# Development Management Officer Report Committee Application

Summary				
Committee Meeting Date: 30 July 2015	Item Number:			
Application ID: Z/2014/0600/F				
Proposal: Erection of 7 apartments (change of house type from that previously approved under planning ref: Z/2007/1648/F) along with associated car-parking and siteworks.  Location: Lands located off Mill Valley Road Ligoniel Road approx 60m to the west of Mill Valley Place Belfast BT14				
Referral Route: Belfast City Council application				
Recommendation:	Approval			
Applicant Name and Address: Belfast City Council	Agent Name and Address: Lagan Homes Ltd 19 Clarendon Road Belfast BT1 3BG

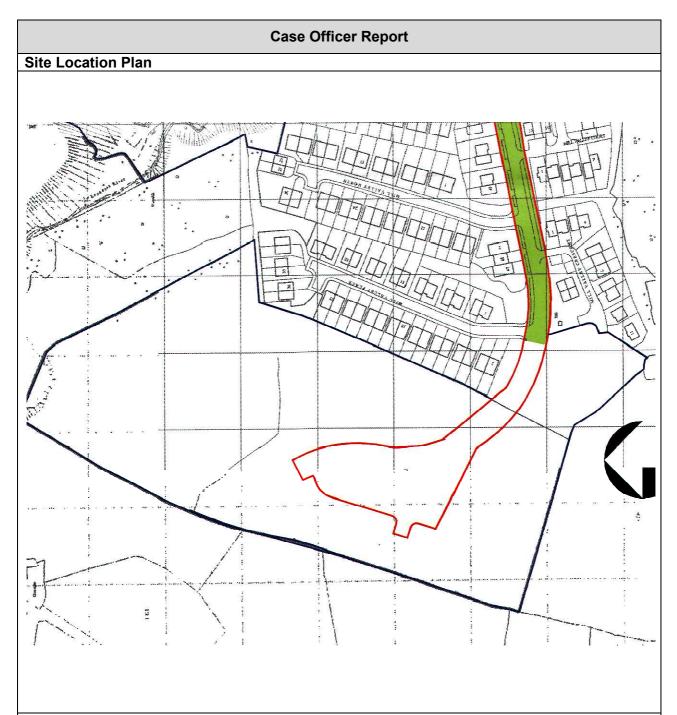
The principle of development on this site has already been established under planning permission Z/2007/1648/F

An amended scheme was submitted on 21 may 2015. This satisfactorily addresses the design issues and is considered acceptable.
